SECTION 009113 – ADDENDUM ONE

- A. Project Name: 22034.02 Meridian High School Additions, Renovations and Ballfield Rebid
- B. Owner: Meridian Public School District, 1019 25th Avenue, Meridian, MS 38391
- C. Architect: Dale | Bailey, an Association, One Jackson Place, Suite 250, 188 East Capitol Street, Jackson, MS 39201-2100
- D. Architect Project Number: 22034.02
- E. Date of Addendum One: 5 January 2024

1.4 REVISIONS TO DRAWINGS

1 ELECTRICAL RENOVATION SITE PLAN
 E-004a Scale: 1" = 40'-0"

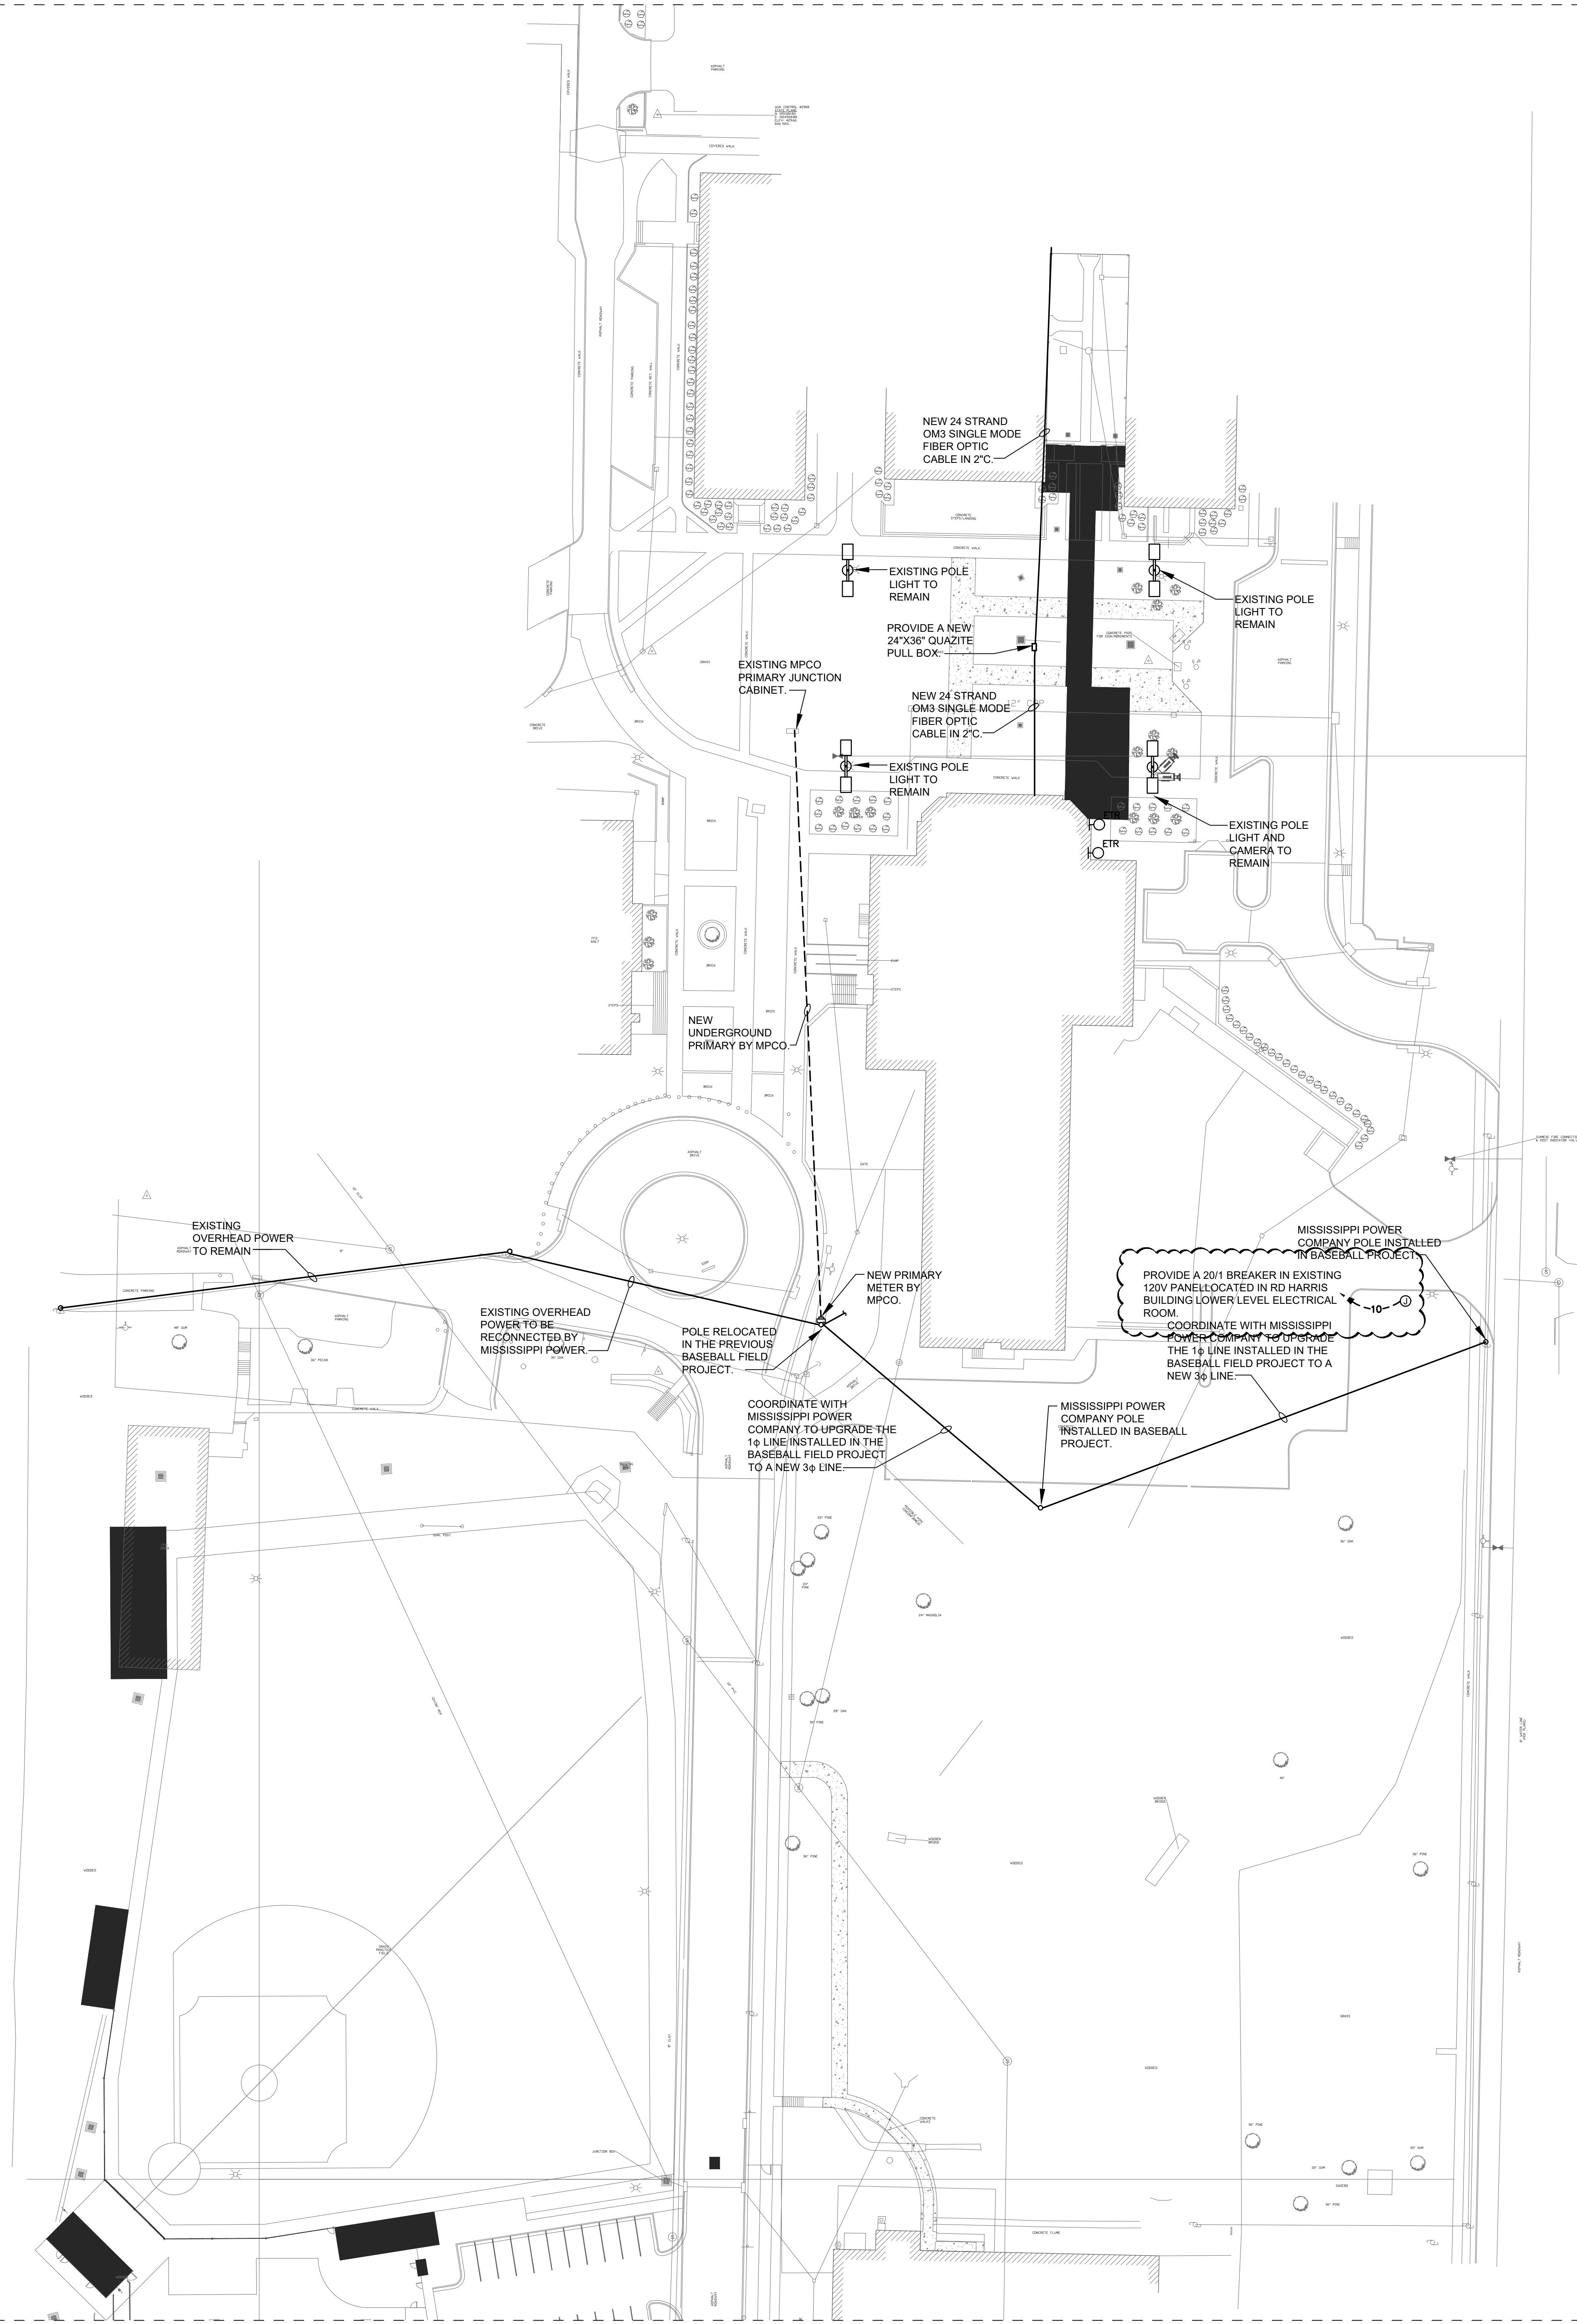
- C. QUESTION: On AS101, it calls for an Auto Gate with Power(East Side of Campus), but I do not see any provisions in the Electrical Drawings. Please Advise.

- S. Sheet C-800 (Revised). Updated to reflect additional erosion control measures.
- T. Sheet E-004a (Revised). Added power for the gate at the east entrance.

ANSWER: See attached updated electrical sheets.
